## Executive Director's Recommendation

Commission Meeting: May 7, 2020

<b>PROJECT</b> <b>Proposed Entrance Alterations</b> 726 Jackson Place, NW Washington, DC	<b>NCPC FILE NUMBER</b> 8164
<b>SUBMITTED BY</b> United States General Services Administration	<b>NCPC MAP FILE NUMBER</b> 1.32(00.00)45108
<b>REVIEW AUTHORITY</b> Federal Projects in the District per 40 U.S.C. § 8722(b)(1) and (d)	<b>APPLICANT'S REQUEST</b> Approval of preliminary site and building plans
	<b>PROPOSED ACTION</b> Approve preliminary site and building plans with comments
	<b>ACTION ITEM TYPE</b> Consent Calendar

# Proposed Entrance Alterations at 726 Jackson Place, NW

# Accessibility Improvements at Courtyard

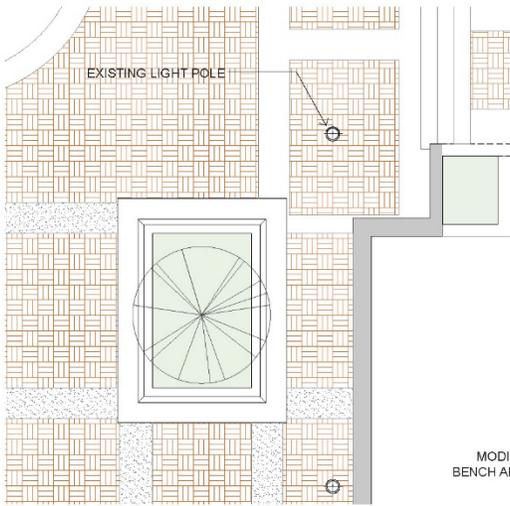
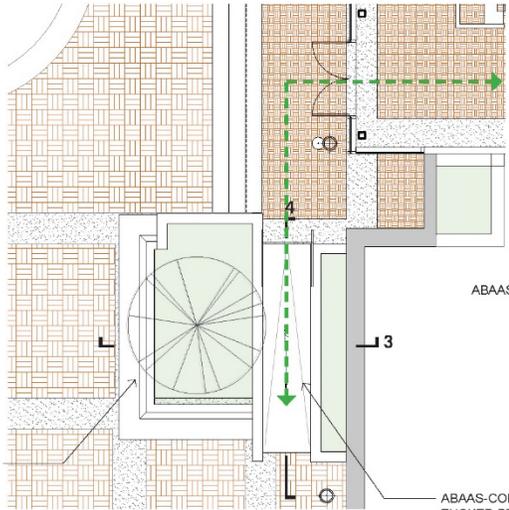
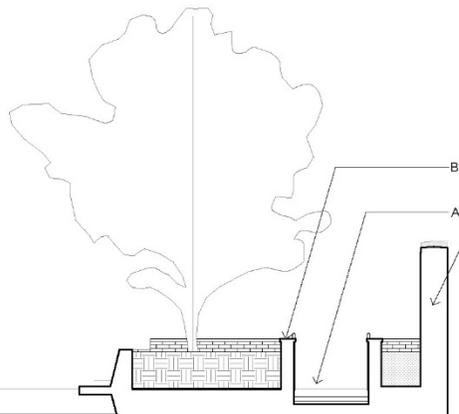
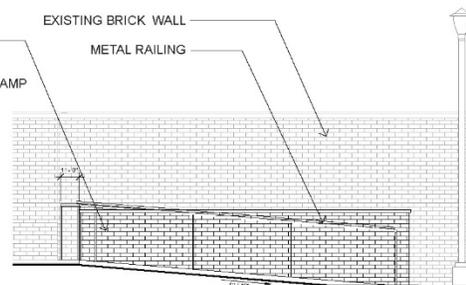
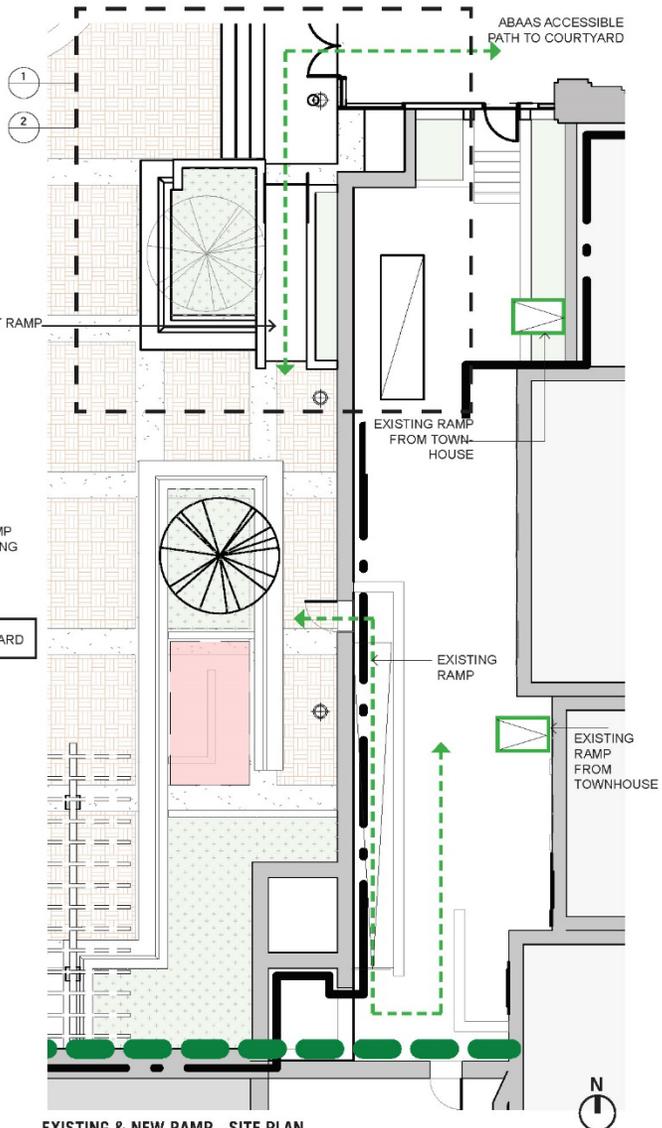
**Requests** the applicant consider options to create a more generous and inviting landing at the entrance to the new addition from the courtyard side. Design options could improve pedestrian circulation by relocating the light poles, widening the landing, or widening the accessible ramp, to help create a more inviting and functional space.

The building addition will require extending the existing raised plinth into courtyard. The existing steps which lead down to the center of the courtyard and its fountain will be shifted to the west to accommodate the expansion. The paving pattern will also be adjusted. As part of the project, a new accessible ramp will be added to allow for access down to the courtyard. The ramp will be located on the south side of the plinth, immediately to the left of the exit from the screening area. After reviewing the plans and renderings, staff believes additional space may be necessary to accommodate pedestrians and those in wheelchairs in the landing area (upon exiting from screening). The door swings, light pole locations, and entry to the accessible ramp are all located in close proximity which may impact pedestrian flow. As such, staff recommends the **Commission requests the applicant consider options to create a more generous and inviting landing at the entrance to the new addition from the courtyard side. Design options could improve pedestrian circulation by relocating the light poles, widening the landing, or widening the accessible ramp, to help create a more inviting and functional space.**

# Wall Extension – Shadow Study

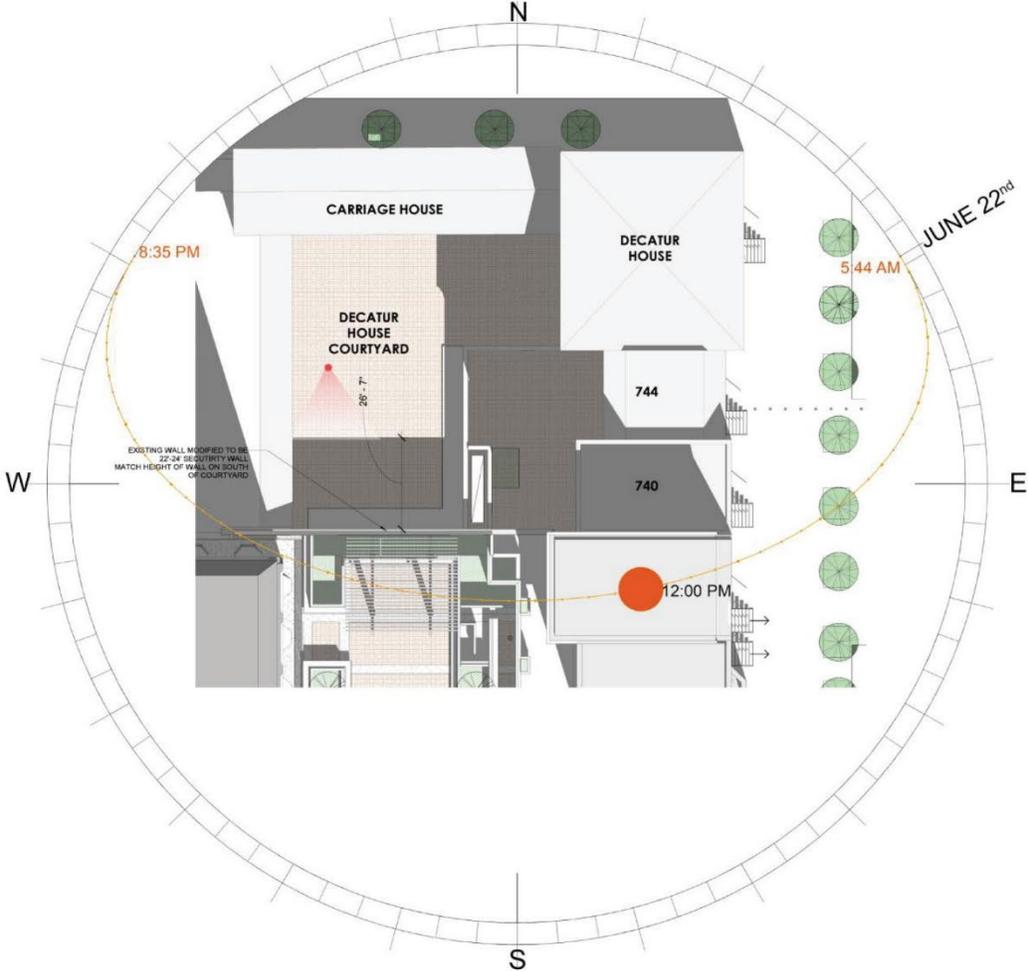
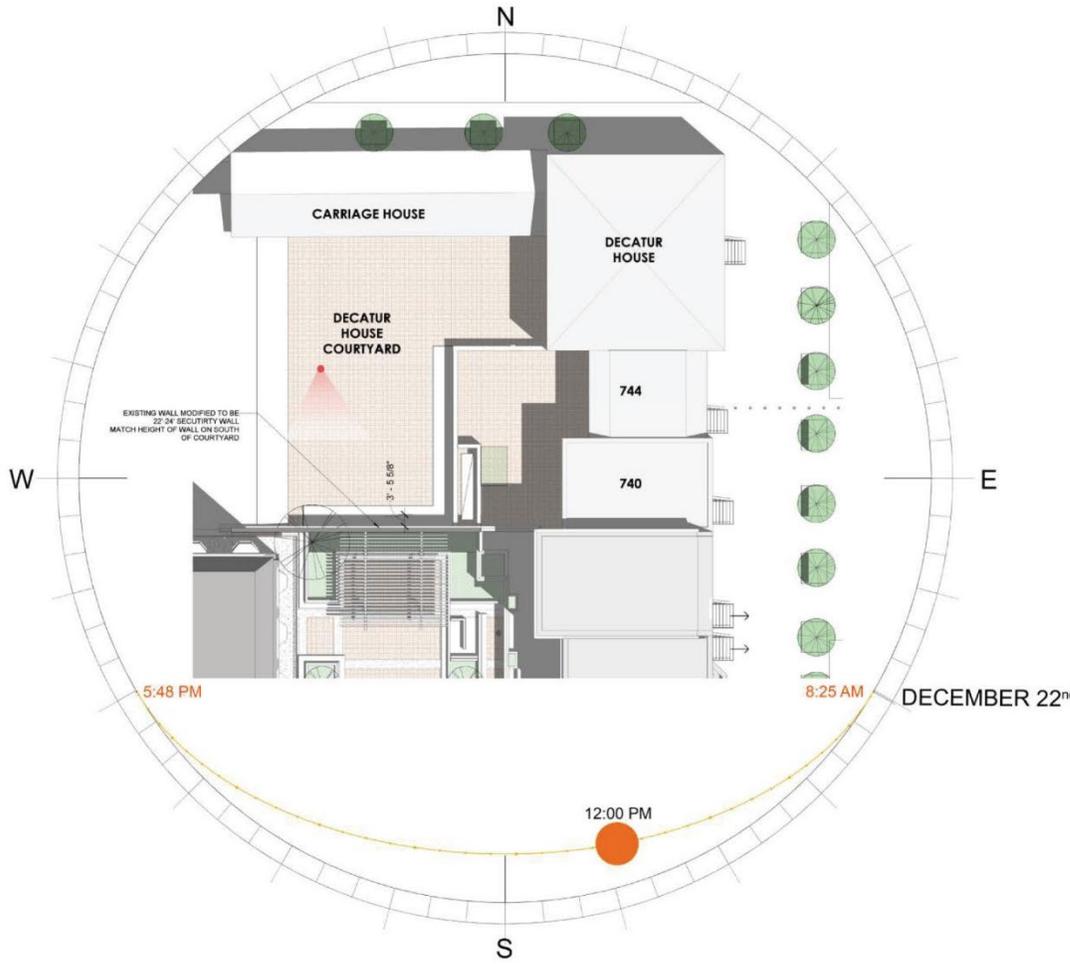
**Requests** the applicant evaluate the use of plantings or vines to help soften the height of the courtyard wall, and to help mitigate the loss of the magnolia tree.

In general, staff understands the rationale for increasing the wall height. The applicant has noted that the wall of the south side of the courtyard (adjacent to Blair House) is similar in height. Shrubs

or vines may be one way to help soften the size and scale of the wall. An existing planter bed adjacent to the wall could be used for new plantings. Therefore, staff recommends the **Commission request the applicant evaluate the use of plantings or vines to help soften the height of the courtyard wall, and to help mitigate the loss of the magnolia tree.**
